SB-13-14-001	R4	May 30, 2	2014	Tesla Service	Motors, Inc. Bulletin			
Defrost Mesh Grille Update								
Classification	Repair Bulletin	Section/Group	14 - Instrument Panel & Pedals	Country/Regior	United States

Model S

Figure 1

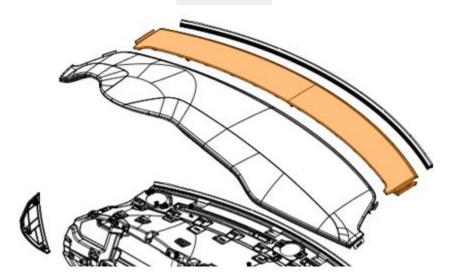
An updated defrost mesh grille is available. The original design meets all federal standards for defrosting the windshield promptly, but the updated grille improves windshield clearing performance in the edges near the LH and RH A-Pillars.

Upon customer complaint, replace the defrost mesh grille with the updated part (Figure 1).

Required Part(s):	Part Number	Description	Quantity
	1023272-00-A	DEFROSTER BEZEL OUTLET LH	1
	1023273-00-A	DEFROSTER BEZEL OUTLET RH	1
	1023274-00-A	DEFROSTER BEZEL BRIDGE	6
	1009344-00-A	SCR PT TRX WSHR M4X1.46-12 ZNBLUE	6
	1023745-00-A	LASER CUT MESH GRILLE DEFROST	1
	1007167-00-B	SEAL MESH DEFROST	2

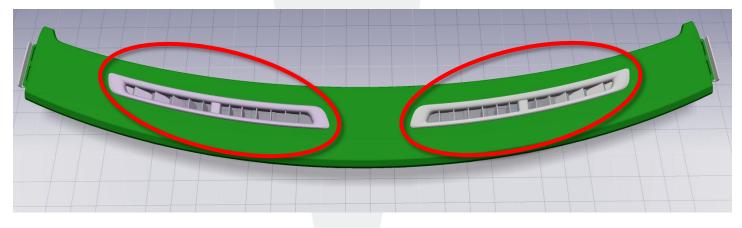
1. Inspect the defrost mesh grille that is inside the vehicle. If the grille has vents that direct air toward the A-Pillars (Figure 2), then the new grille is already installed and no more work is needed.
